Gas Processing Facility Inspection Form

Section 1: General Information				
Operation Data	Inspection Data			
Operator Name:	Inspector Name:			
NW Gas Processing LLC / SROG	James Thum			
Location Name:	Area Office:			
Highway 30 Gas Processing Facility	Boise / Director's office			
Authorized Contact: Dan Johanek (208) 800-9503 Tyler Hartung (208) 412-5475	Inspection Date: September 22, 2023, 10:15 AM			
County: Payette	Report Date: September 25, 2023			
Inspector's Signature:	Inspection Summary:			
James Thum	 Operation appeared to be in compliance at the time of the inspection. 			
Date of Signature: September 25, 2023	Issues of concern identified at the time of the inspection.			
Location Description: 4201 US 30, New Plymouth ID				
Exit 9. Facility is no longer manned 24 hours. SROG has re-located the field office to a store front located at 112 N. Plymouth Ave, New Plymouth ID 83655.				
Time of Inspection: 10:15 AM – 11:15 AM				
Weather: Partly cloudy, calm winds 0-5 MPH, 48-50°F

Tear in portable spill containment device used for chemical storage south of pig launcher / catcher.

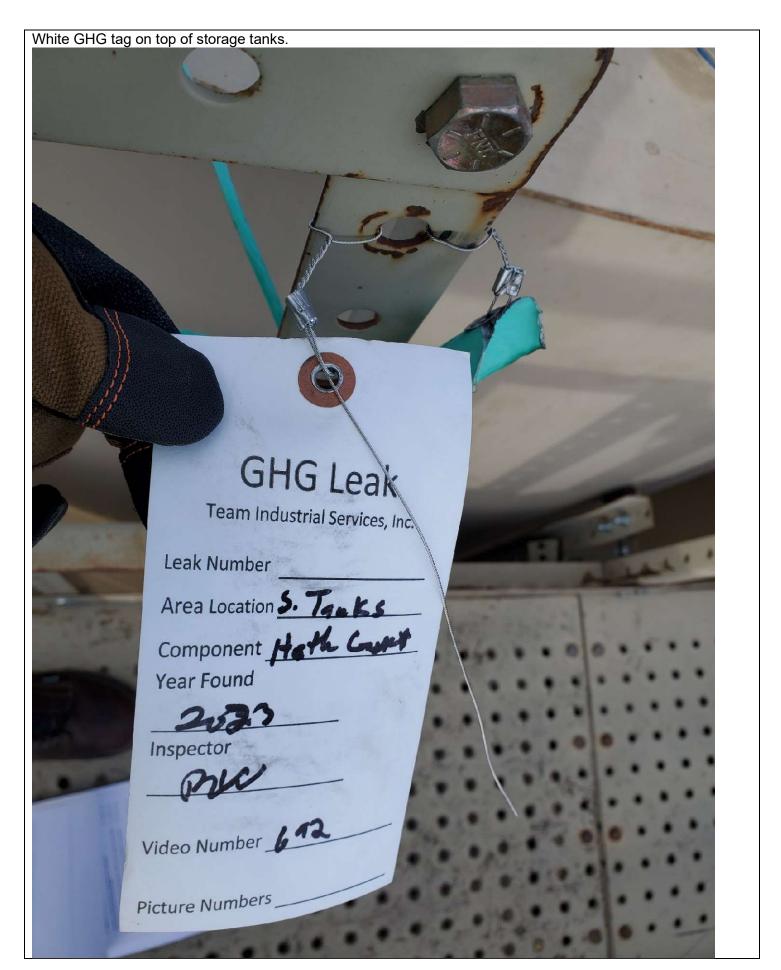
- Section 4, Item 2: Portable spill containment device is breached (cut) on the east side approximately 14 inches along side and bottom (photos).
- Section 4, Item 5: Weeds on site are generally <5% with the exception of the west side from the pig launcher/catchers south to the flare stack. Weed abatement needed in the vicinity of the storage tanks, in and outside of the containment berm.

Plastic five-gallon buckets for lubrication spill containment at condensate stabilizer unit.

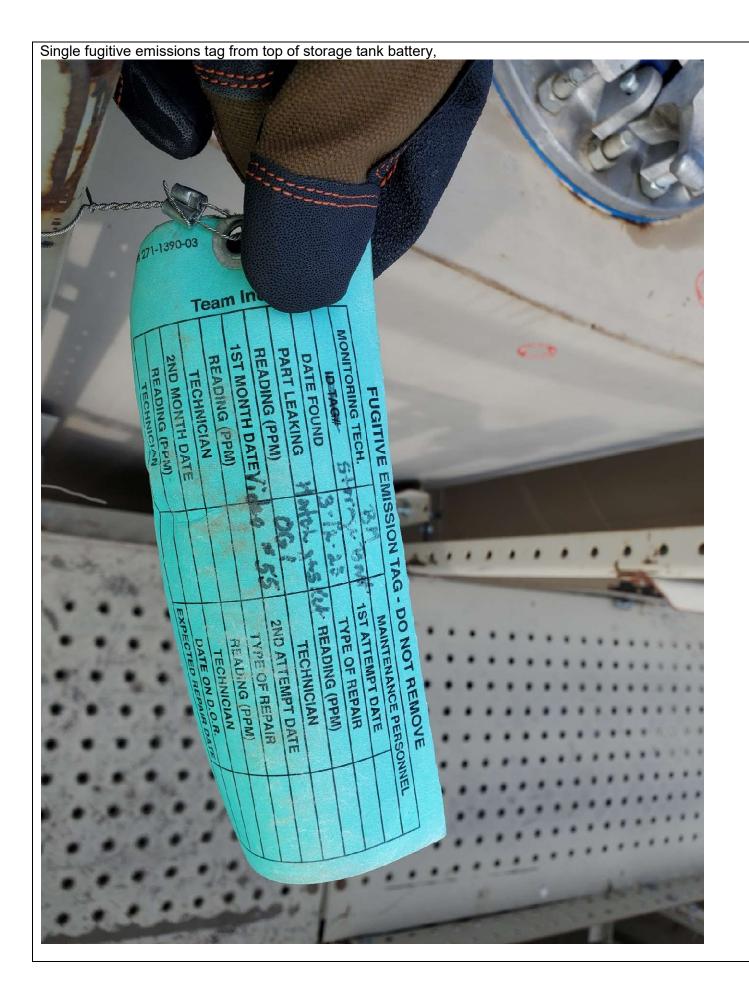
- Green fugitive emissions tags were also noted at the 4-inch pig launcher and condensate stabilizer units.
- Plastic buckets with no secondary spill containment devices were being used at the condensate stabilizer. IDL recommended a secondary device or other back-up method needs implemented for potential spills.
